FINAL FIELD TASK MODIFICATION REQUEST FOR ADDITIONAL PCB SOURCE
DELINEATION SAMPLING, ROCK CORING AND SEDIMENT TRAP INSTALLATION AT
SOLID WASTE MANAGEMENT UNIT 17 (SWMU 17) PCB CAPACITOR BURIAL POLE YARD
NSA CRANE IN
06/01/2015
TETRA TECH INC

Final Field Task Modification Request for Additional PCB Source Delineation Sampling, Rock Coring, and Sediment Trap Installation at SWMU 17 - PCB Capacitor Burial/Pole Yard

Naval Support Activity Crane, Indiana

Naval Support Activity (NSA) Crane	CTO F270, 112IG05219	NA
Project/Installation Name	CTO and Project Number	Task Mod. Number
QAPP Addendum No. 4 (See Table 1)	SWMU 17	6/1/2015
Modification To (e.g., Work Plan)	Site/Sample Location	Date

CONTRACT NUMBER	CTO NUMBER F271
APPROVED BY	DATE
APPROVED BY	DATE
FIGURE NO. 6	REV 0

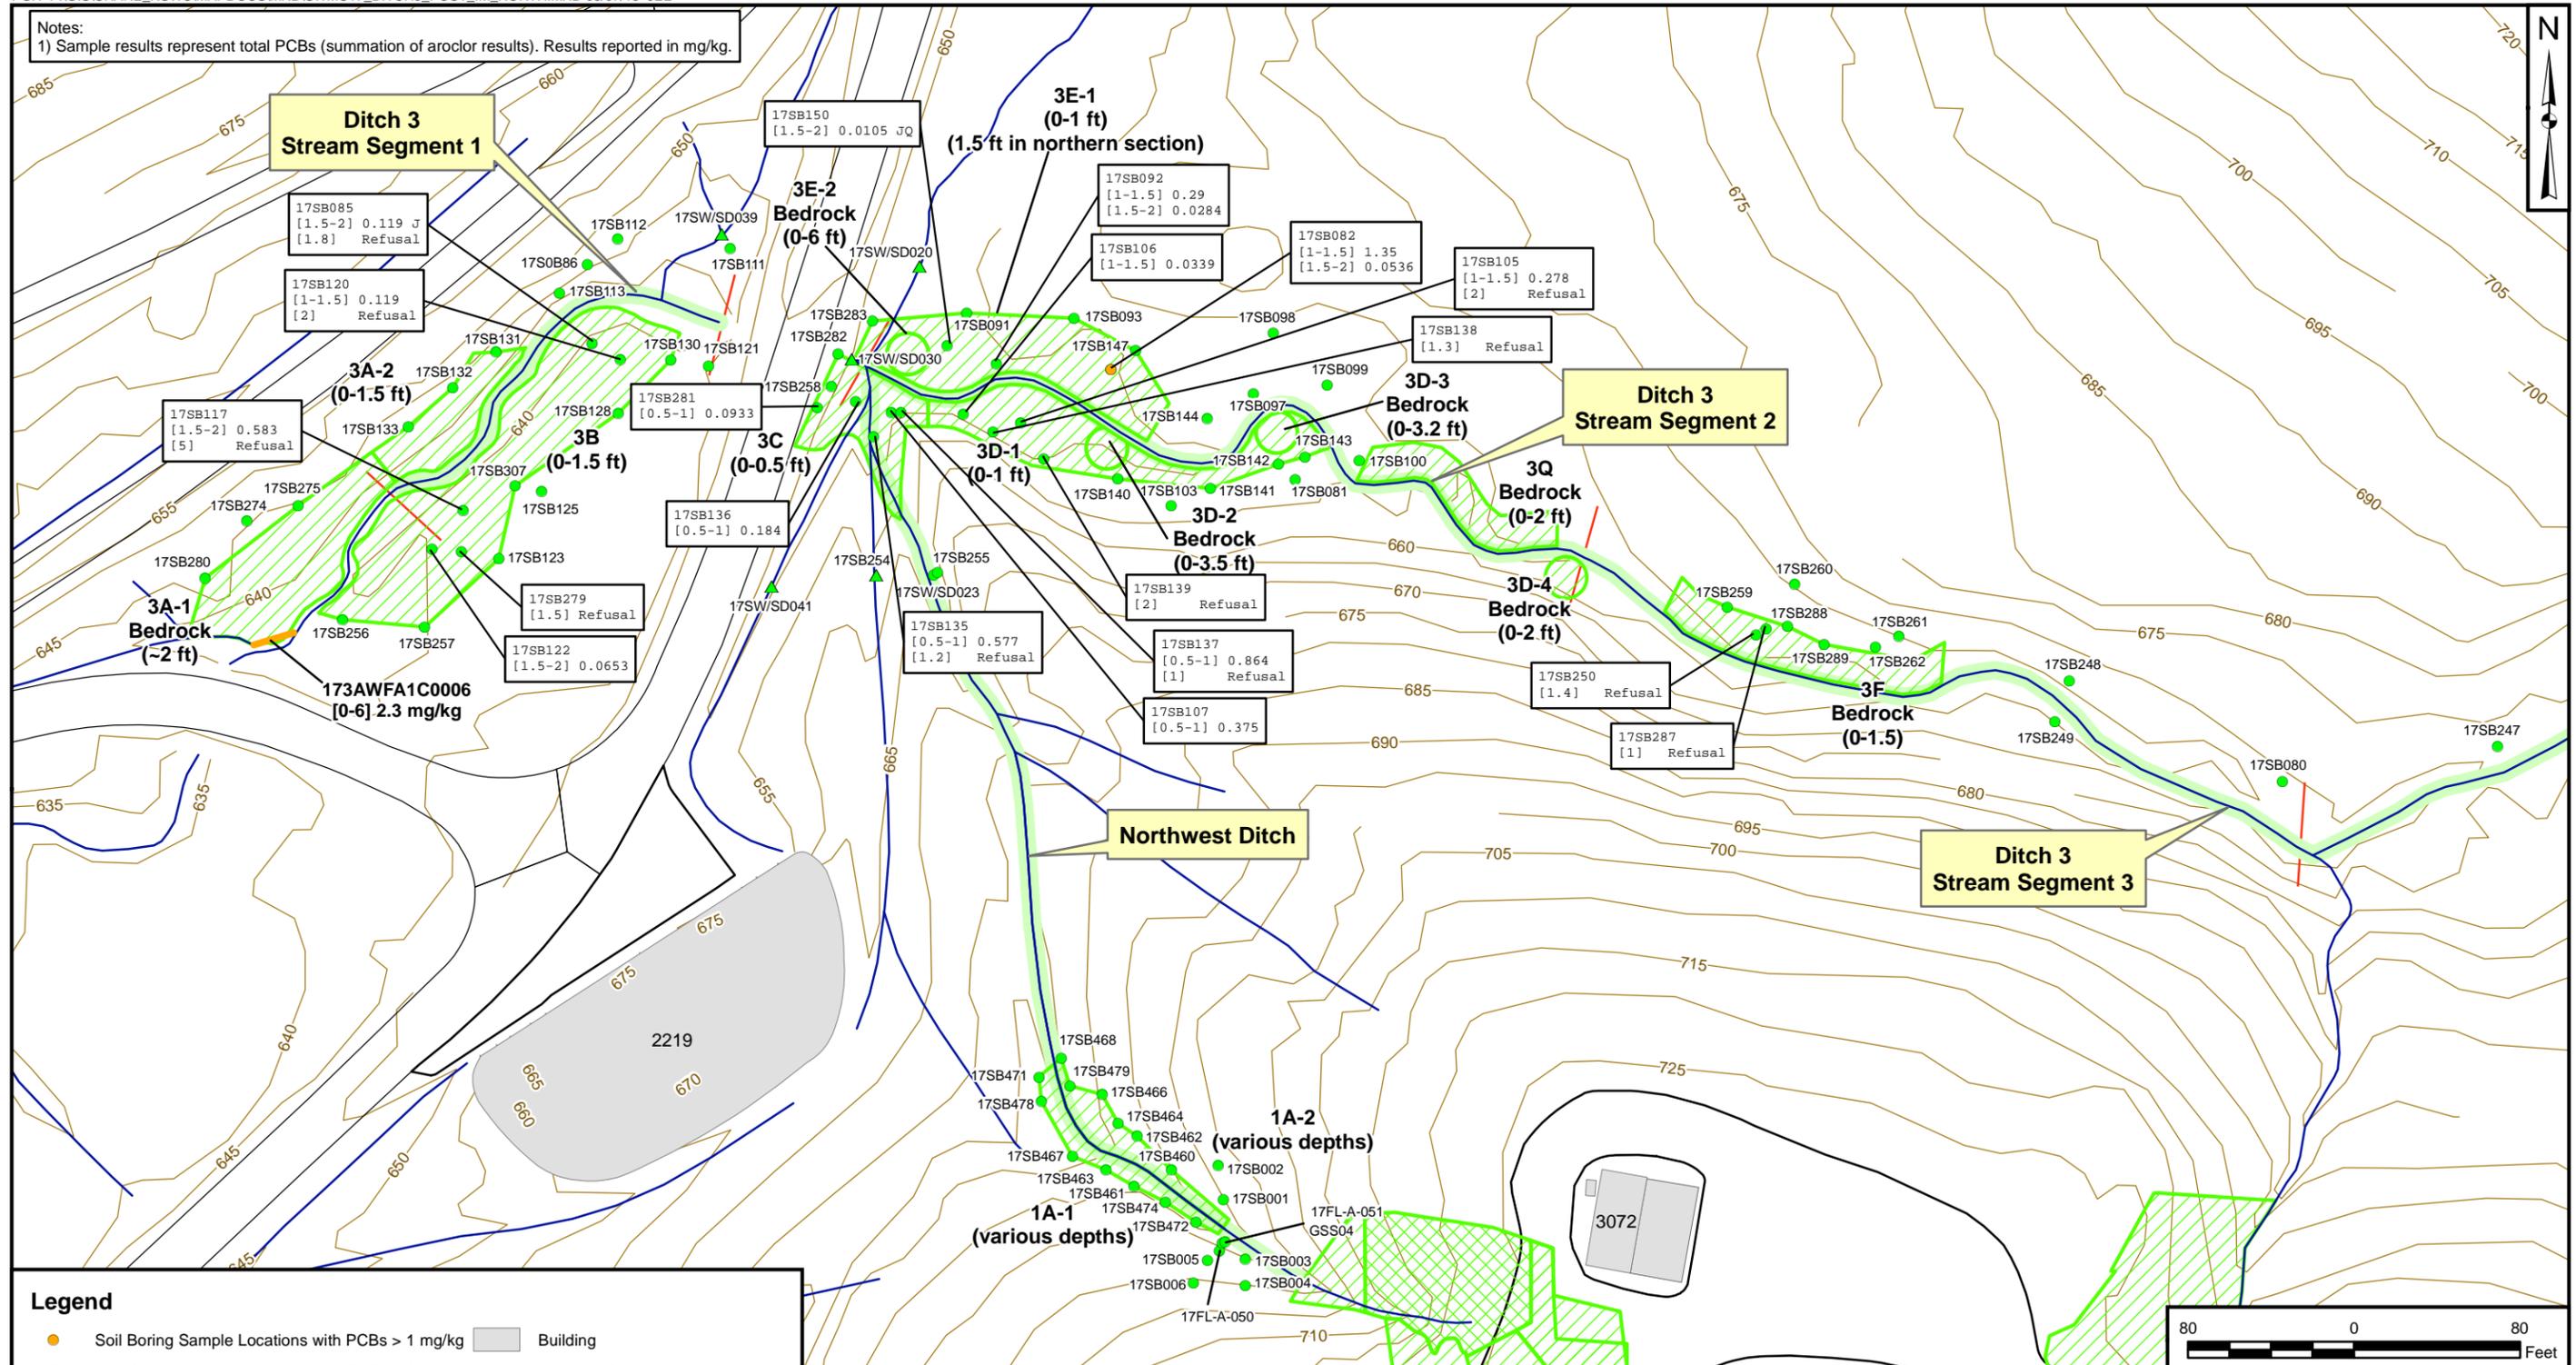
- The southwestern edge of Ditch 3 Segment 1 within Boggs Creek (Figure 6) near previously collected sample 173AWFA1C0006.
- The easternmost area of Ditch 3 Segment 6 near Building 2721 (Figure 2, green-colored rectangle at top of Ditch 3).

Figure 6 shows the location of previously collected sample 173AWFA1C0006 (at the southwestern end of Ditch 3 Segment 1), which was collected at a depth approximately 4 feet below the current ground surface. The area around this location is the area in which soil sample collection is planned. Table 2 lists the first few planned samples and their associated sample depths.

FIGURE A4-1 SEDIMENT TRAP INSTALLATION DESIGN DETAILS

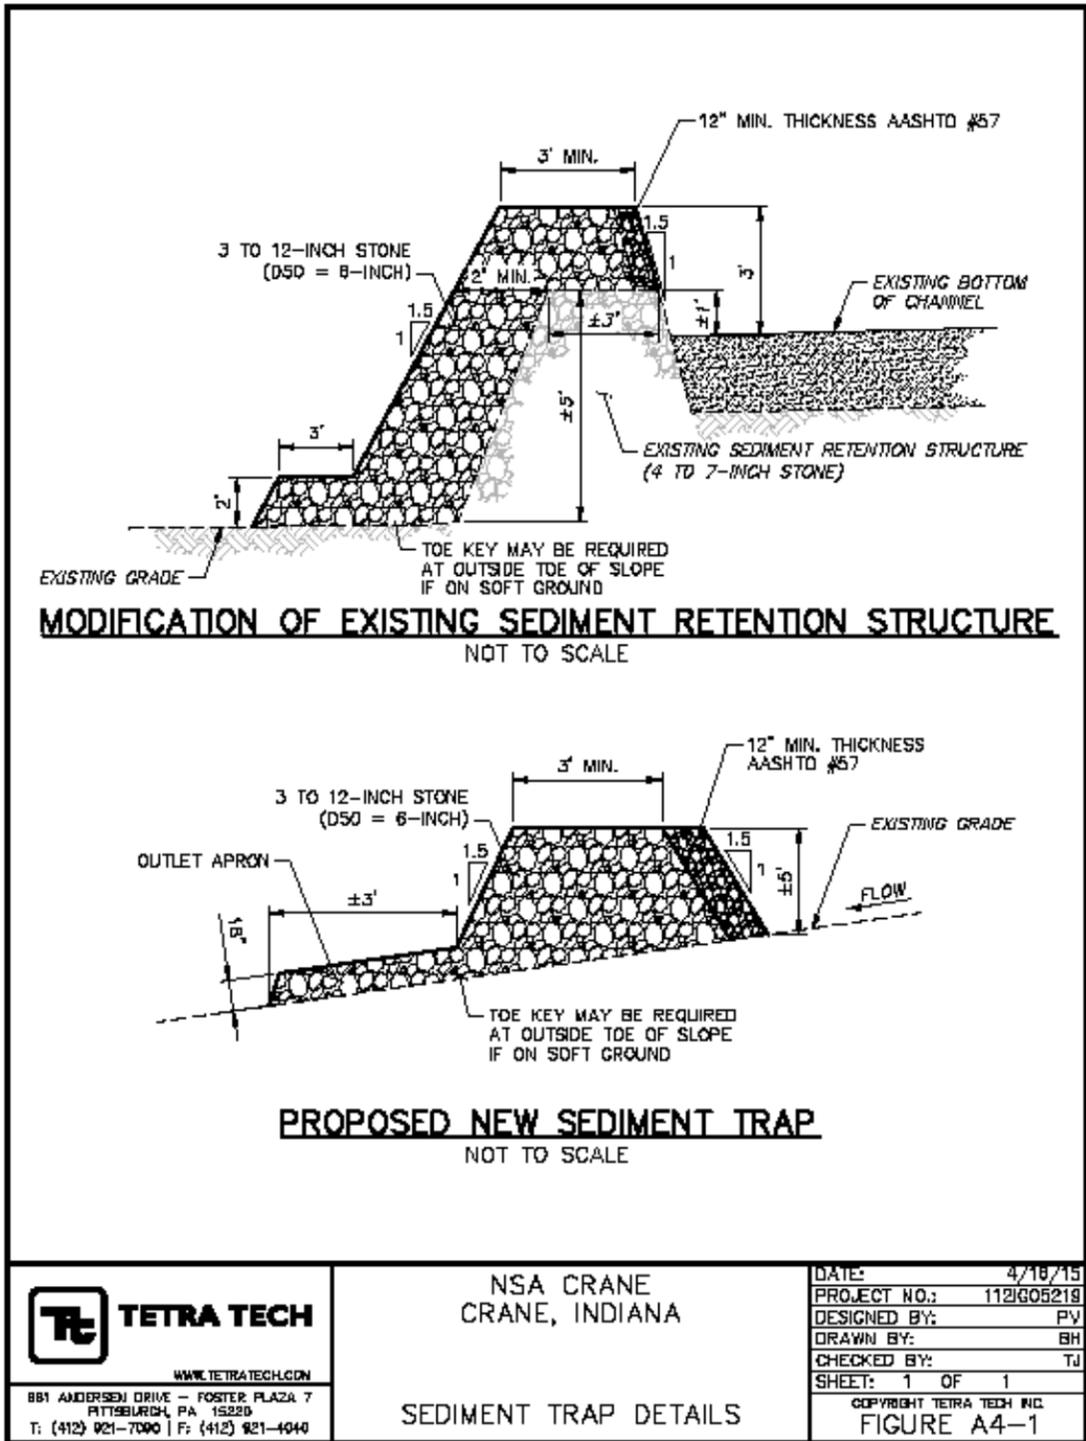
Because of potential downstream migration of contaminated sediment after completion of IM Phase 2, installation of sediment traps is planned to prevent continued downstream migration of PCB-contaminated sediment. One trap will actually be an expansion of an existing sediment retention structure (see Figure 3). The intent will be to raise the top elevation of this structure to 3 feet above the Ditch 3 bed elevation, an increase of approximately 2 feet to the structure height. The second sediment trap will be installed farther downstream of this current retention structure. The siting of this second trap will be designed to prevent migration of PCB-contaminated sediment farther downstream from the location of farthest known contaminated sediment migration. Construction details are provided in Figure 4A-1. This figure is not to scale.
